## ***Interactive comment on “Quantifying flow and remediation zone uncertainties for partially opened wells in heterogeneous aquifers” by C.-F. Ni et al.***

**C.-F. Ni et al.**

Received and published: 5 May 2011

Figure: The mean head distribution for fixed  $z$  ( $z=10\text{m}$ ) and along  $r$ -direction for cases with and without nonlinear terms in equation

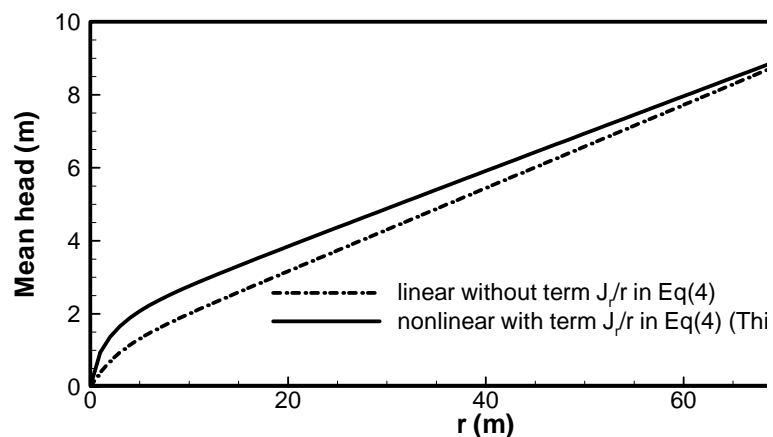
Figure 3 shows the mean head distribution for our test example. As shown in Equation (4), there is a nonlinear term ( $J_r/r$ ) for our model to show the result of mean head along  $r$ -direction. I'm not really sure if I fully understand the point raised by referee #1. In the attached figure, we plot the head profiles along the center line (along  $r$ -direction and fix  $z = 10$ ) with and without the  $J_r/r$  term. The figure clearly shows that the differences of mean head values along  $r$ -direction, especially near the well location. One possible factor to show relatively flat flow pattern may be the constant head boundary condition applied at well screen location in this study. Constant head and constant flux boundary conditions for well locations were previous discussed in detailed by Indelman and Dagan (2004).
